HISTORIC AND DESIGN REVIEW COMMISSION

HDRC CASE NO: 2019-660
ADDRESS: 132 CAMARGO
LEGAL DESCRIPTION: NCB 923 BLK 4 LOT N 75FT OF E 27.8FT OF 6 & N 75FT OF 7
ZONING: RM-4,H
CITY COUNCIL DIST.: 1
DISTRICT: Lavaca Historic District
APPLICANT: Robert Alvarado
OWNER: Beanville Bungalows
TYPE OF WORK: Dismantling, relocation, and reconstruction of primary structure
APPLICATION RECEIVED: October 10, 2019
60-DAY REVIEW: December 09, 2019
CASE MANAGER: Stephanie Phillips
REQUEST:

The applicant is requesting a Certificate of Appropriateness for approval to:

126, 130, & 132 CAMARGO -
PROPOSED SITE PLAN

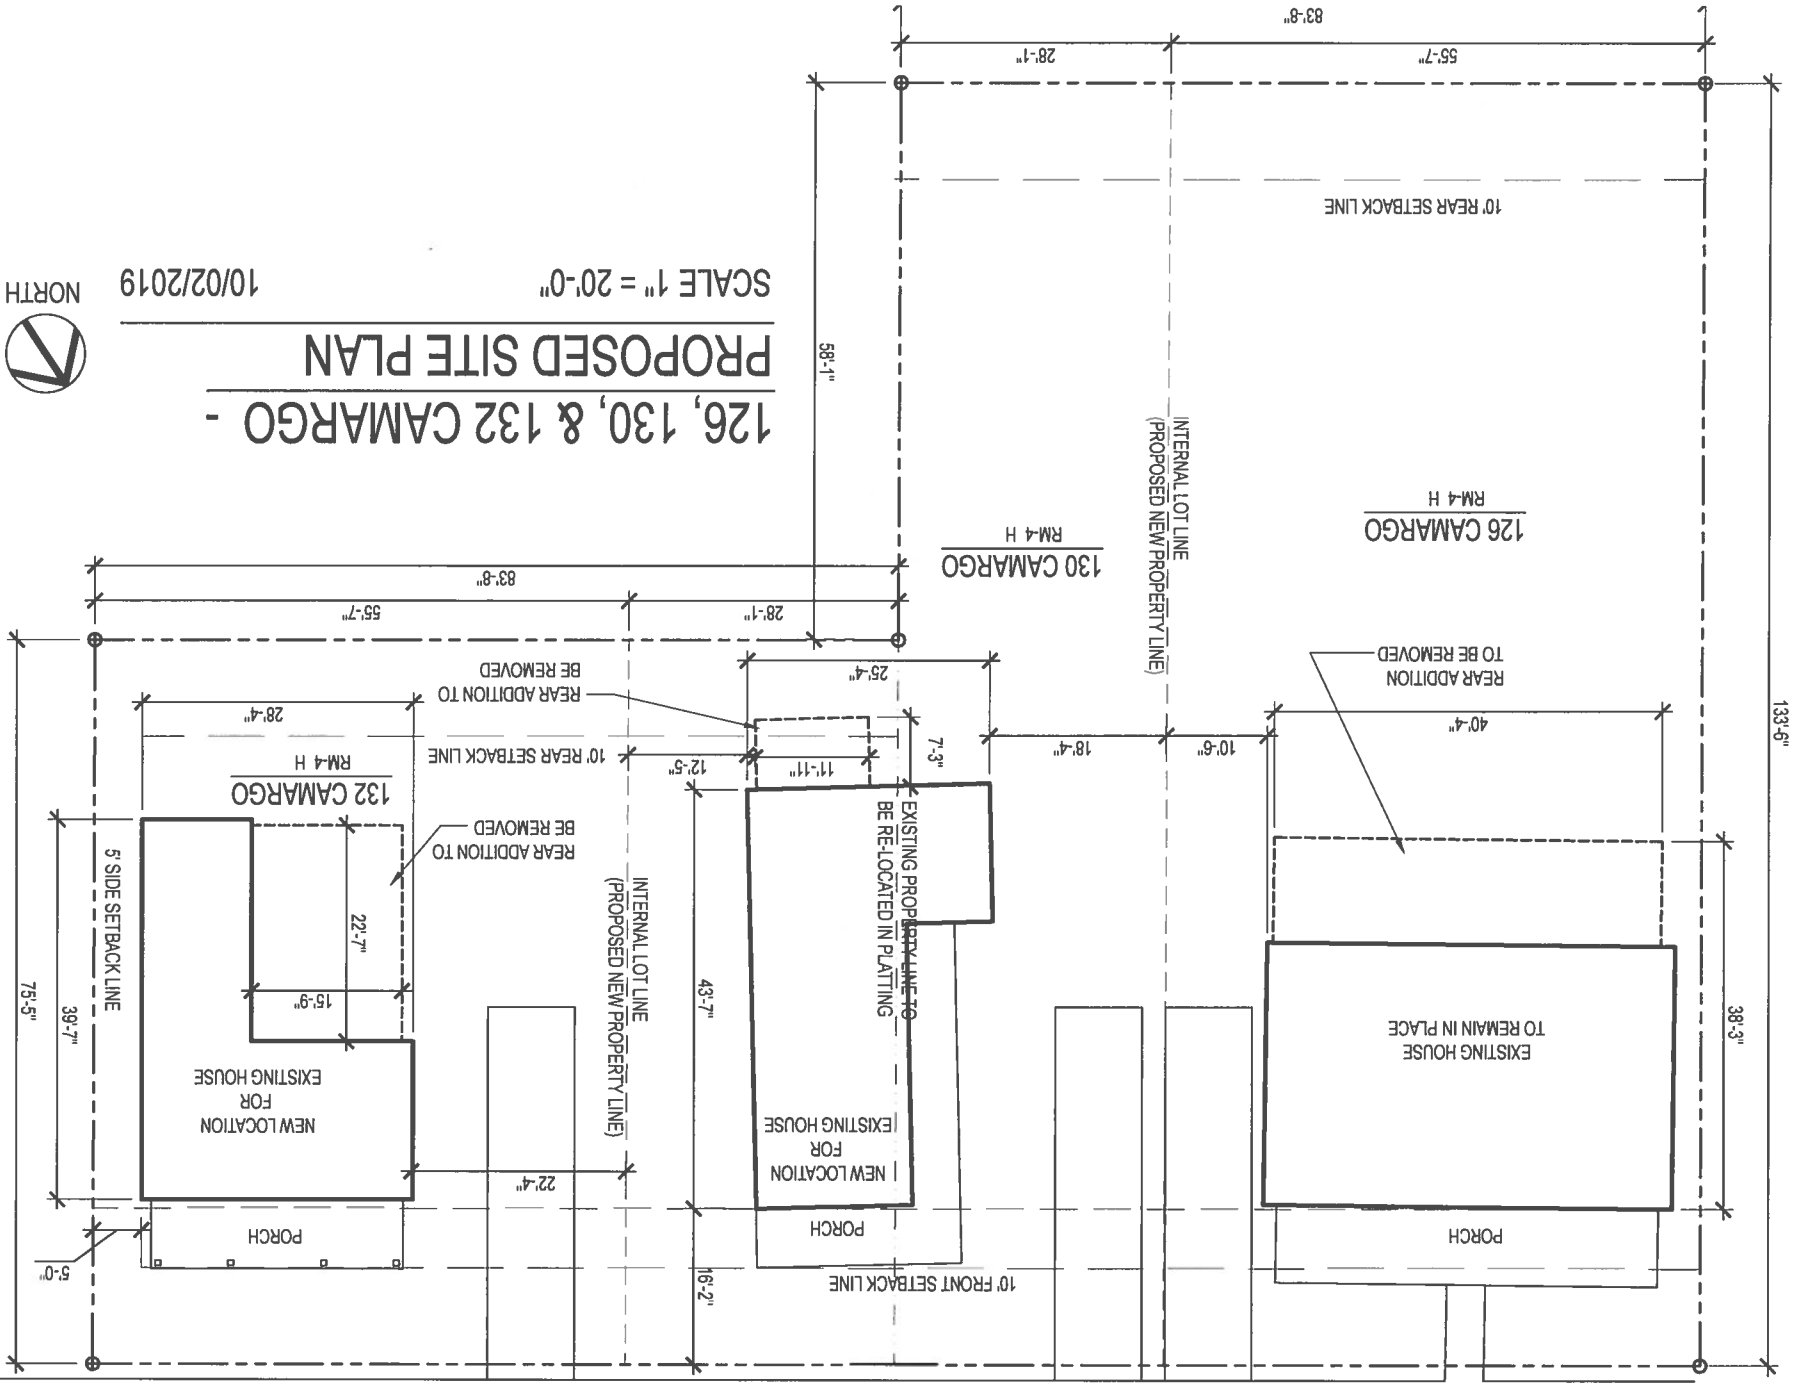
- d. RELOCATION – The applicant has proposed to relocate the structure approximately 12 feet to the east on the same lot. The new location will be 5 feet from the east property line along San Arturo and will position the structure as a corner lot residence. The lot, along with lots addressed 130 and 126 Camargo, will be replatted to adjust the property lines and three create single family lots. Staff generally finds intact relocation to be appropriate based on the historic development pattern of the district.

- f. DRIVEWAY AND CURB CUT – The applicant has proposed to install a new concrete driveway to the west of the relocated structure. The applicant has not indicated a proposed width. Staff generally finds the proposal to be appropriate with the stipulation that the driveway be no wider than 10 feet.

- vi. That the proposed concrete driveway be no wider than 10 feet and that the approach flare be no wider than 12 feet at its widest point.
